MATERIALS LICENSE

SUBJECT: SSD TECHNICAL ASSISTANCE REQUEST:
DETECTION SYSTEMS, INC.
CONTROL NO. - 021802
LICENSE NO. - 31-23818-01E

REGISTRY OF RADIOACTIVE SEALED SOURCES AND DEVICES
SAFETY EVALUATION OF DEVICE
(AMENDED IN ITS ENTIRETY)

Re: Amendment to License #: 31-23818-01E

Figure A

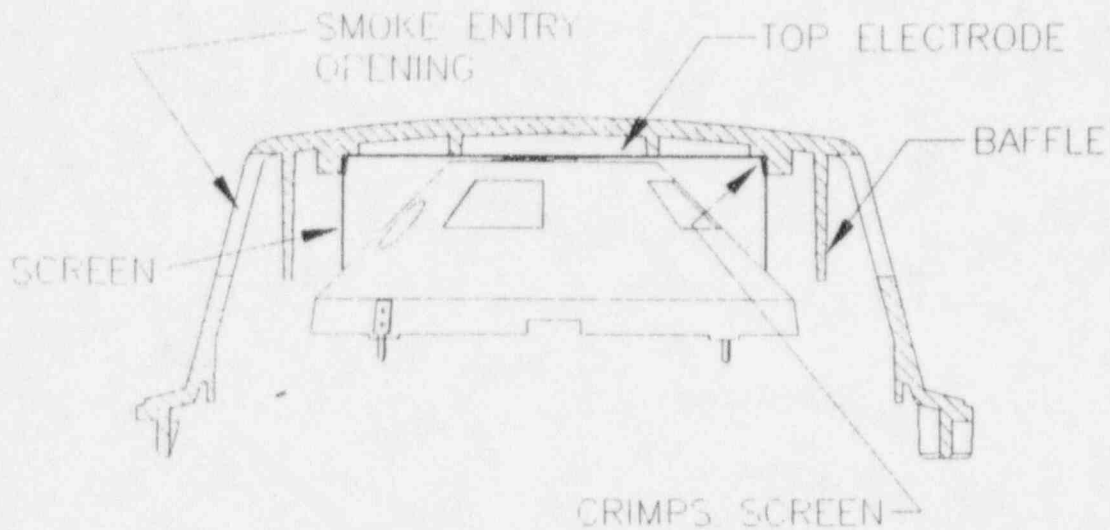
1. As stated in Summary Data 3.3, and as can be seen on the attached figures A and B, the openings to the metal cover are completely covered with a screen. In addition, baffles are molded into the plastic cover to provide additional blockage of the holes. We apologize that the screen was not clearly labeled in our original drawings.

3. Regarding the attachment of the outer electrode to the metal screen, the screen is crimped between the plastic cover and the top electrode as shown in Figure A. There is a spring tab on the top electrode that makes a spring loaded pressure contact with the outer electrode. This is shown in the enclosed drawing C24353 (Rev. C).

FIG. 4 NOT TO SCALE

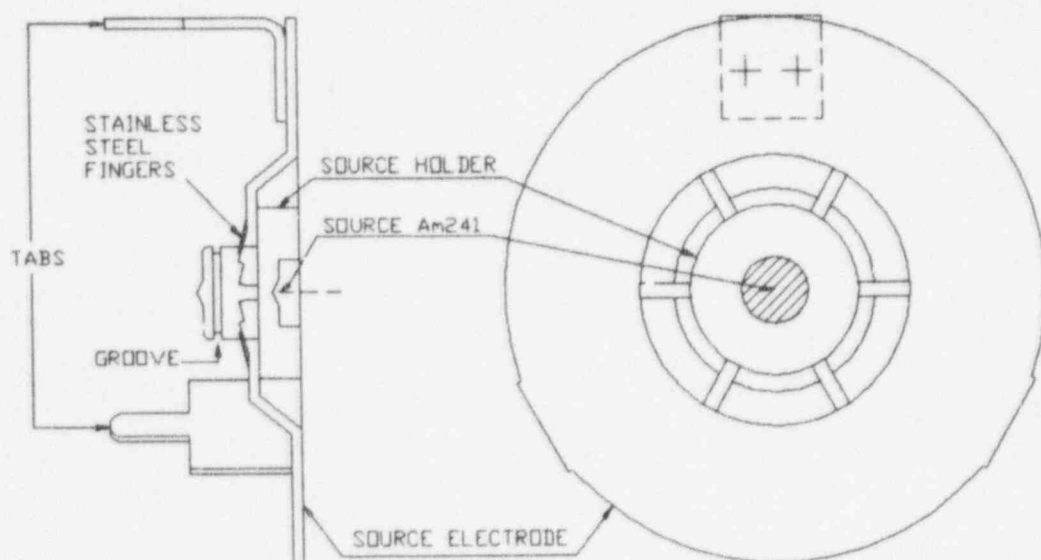
2. The flange and retaining ring were used in our original design. In our new design, for which we requested the amendment, we replaced the flange and retaining ring with a groove and stainless steel fingers. As demonstrated in Figure 4 of Summary Data 3.3, the source electrode has stainless steel fingers that snap over this groove and are seated against the shaft. The source holder is captive after being inserted into the source electrode. If for some reason the source holder should slip in the direction that would cause it to come out of the source electrode, the stainless steel fingers will snap into the groove on the source holder shaft and prevent additional slippage. Removal can only be accomplished by first unsoldering and decrimping (straightening) the outer electrode tabs. The middle electrode must then be unsoldered and removed. The source electrode with the source holder and source may then be unsoldered, decrimped and removed. The source holder can then be removed from the source electrode only by driving it out with a hammer and punch.

A groove on the source holder is located near the base of a shaft. The source electrode has stainless steel fingers that snap over this groove and are seated against the shaft. The source holder is captive after being inserted into the source electrode. If for some reason the source holder should slip in the direction that would cause it to come out of the source electrode, the stainless steel fingers will snap into the groove on the source holder shaft and prevent additional slippage. Removal can only be accomplished by first unsoldering and decrimping (straightening) the outer electrode tabs. The middle electrode must then be unsoldered and removed. The source electrode with the source holder and source may then be unsoldered, decrimped and removed. The source holder can then be removed from the source electrode only by driving it out with a hammer and punch. (See Figure 4)

Drop testing of the unit confirmed that neither the flange nor the retaining ring were necessary to secure the source holder in the source electrode. After repeated drops from 10 meters, the stainless steel fingers of the source electrode held the source holder in place with no apparent relative change in position.
